Access Compliance Report

Public Rights-of-Way

(Curb Ramps)

Intersection ID: 14880	Main Street: ALBEMARLE_RD	Cross Street: KINGHURST_DR	Location: NE
ADA ID: AE0F169CC67D	Ramp Type: Perp	Initial Pass/Fail: Fail	Overall Compliance: No
Severity Score: 12.5			
Codes/Mitigation Info/Possible Solution		Field Measurements/Component Compliance

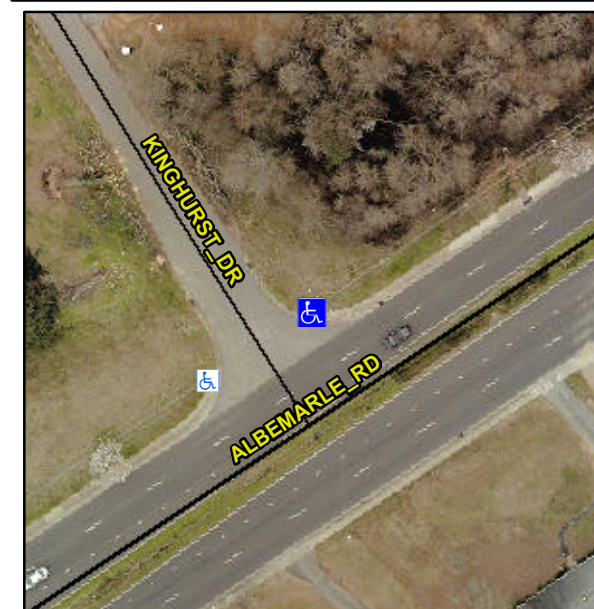
Not Found, R304.2.2

Compliance	Description	Data	Compliance	Description	Data
N/A	Ramp Length (in)	60.0	No	Ramp Slope (%)	8.6
Yes	Ramp Width (in)	48.0	Yes	Ramp XSlope (%)	1.0
N/A	Flare Type LT	N/A	N/A	Flare Type RT	N/A
N/A	Flare Slope LT (%)	N/A	N/A	Flare Slope RT (%)	N/A
N/A	Flare Traversable LT?	N/A	N/A	Flare Traversable RT?	N/A
N/A	Landing Length (in)	N/A	N/A	DWS Provided?	N/A
N/A	Landing Width (in)	N/A	N/A	DWS Contrast?	N/A
N/A	Landing Slope (%)	N/A	N/A	DWS Length (in)	N/A
N/A	Landing X Slope (%)	N/A	N/A	DWS Full Width?	N/A
N/A	Landing Curb? (Y/N)	N/A	N/A	DWS Offset (in)	N/A
N/A	Shared Landing?	N/A			
N/A	Gutter Ponding?	N/A	N/A	Gutter Slope (%)	N/A
N/A	Gutter Lip Ht (in)	2.0	N/A	Gutter X Slope (%)	N/A
N/A	Painted X Walk1?	No	N/A	Painted X Walk2?	N/A
	X Walk 1 Direction	To SW		X Walk 2 Direction	N/A
N/A	X Walk 1 Width (in)	N/A	N/A	X Walk 2 Width (in)	N/A
	X Walk 1 Slope (%)	2.3		X Walk 2 Slope (%)	N/A
	X Walk 1 X Slope (%)	0.6		X Walk 2 X Slope (%)	N/A

Remove & Replace Entire Ramp.
